SUBJECT: Duke Energy Corporation
Catawba Nuclear Station, Units 1 and 2
Docket Nos. 50-413 and 50-414
NRC Generic Letter 2004-02, "Potential Impact of Debris Blockage on Emergency Recirculation During Design Basis Accidents at Pressurized-Water Reactors"

Response to Request for Additional Information

Figure 5-1
Catawba LBLOCA Expected Beginning and End of Life Sump pH Response

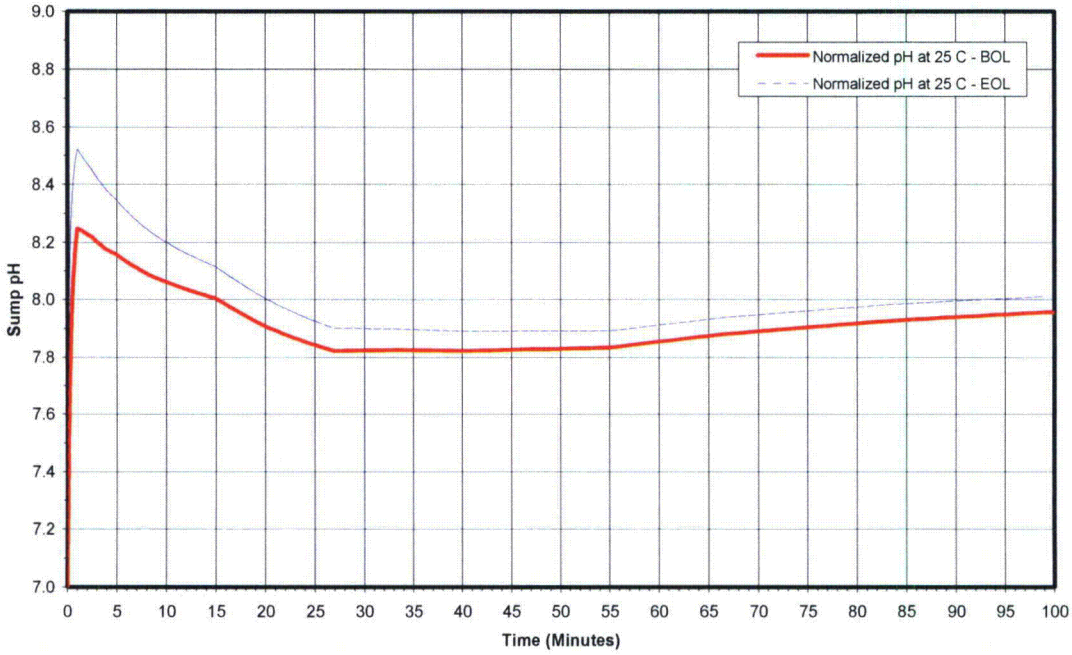
Provide the expected containment pool pH during the emergency core cooling system (ECCS) recirculation mission time following a LOCA at the beginning of the fuel cycle and at the end of the fuel cycle. Identify any key assumptions.

An analysis was performed to document how the ECCS sump pH was affected by both Beginning-of-Life (BOL) and End-of-Life (EOL) boron concentrations in the reactor coolant inventory. The EOL scenario, consisting of much lower concentrations of boron in the reactor coolant inventory, yields a higher sump pH profile than the same analysis for the BOL assessment. Figure 5-1 shows the time-dependent sump pH profile for both BOL and EOL cases, normalized to 25 °C.

The Catawba ECCS sump pH analysis shows that by 2 hours after LBLOCA initiation all of the water from the RCS, Refueling Water Storage Tank (FWST), Cold Leg Accumulators (CLAs), and the ice melt from the Ice Condenser will be in the sump. Continuing nitric acid and hydrochloric acid production due to irradiation of the water/air mixture and of the electrical cable insulation/jacket material inside containment will be a long term contributor to the pH value of the sump. In order to address the impact of this effect, a sensitivity analysis was performed and showed that when the time range is expanded beyond 2 hours, there is an insignificant change in the ECCS sump pH.

Figure 11-1

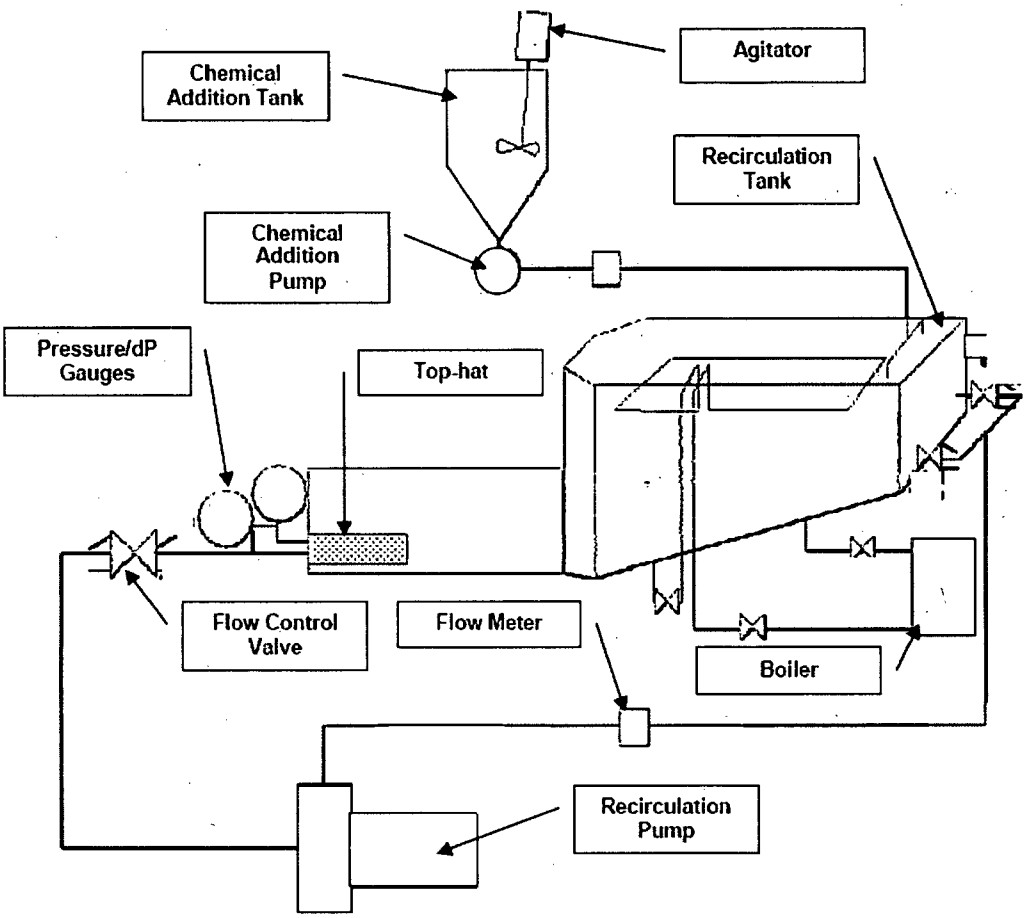
Provide a detailed description of any testing that has been or will be performed as part of a plant-specific chemical effects assessment. Identify the vendor, if applicable, that will be performing the testing. Identify the environment (e.g., borated water at pH 9, deionized water, tap water) and test temperature for any plant-specific head loss or transport tests, Discuss how any differences between these test environments and your plant containment pool conditions could affect the behavior of chemical surrogates. Discuss the criteria that will be used to demonstrate that chemical surrogates produced for testing (e.g., head loss, flume) behave in a similar manner physically and chemically as in the ICET environment and plant containment pool environment.

A 36-inch long prototype top-hat module was utilized in the IPT test loop. This length is representative of the population of top-hat modules available on the McGuire Unit 1 and 2 modified strainers (24 inch, 30 inch, 36 inch and 45 inch) and dimensionally similar to the population of top-hat modules available on the Catawba Unit 1 and 2 modified strainers. All other top-hat parameters (e.g., base plate, mesh size, diameter) on the test prototype module are identical to those installed in the McGuire and Catawba ECCS sumps, including the bypass eliminator feature.

Figure 11-1 below shows the physical IPT rig setup.
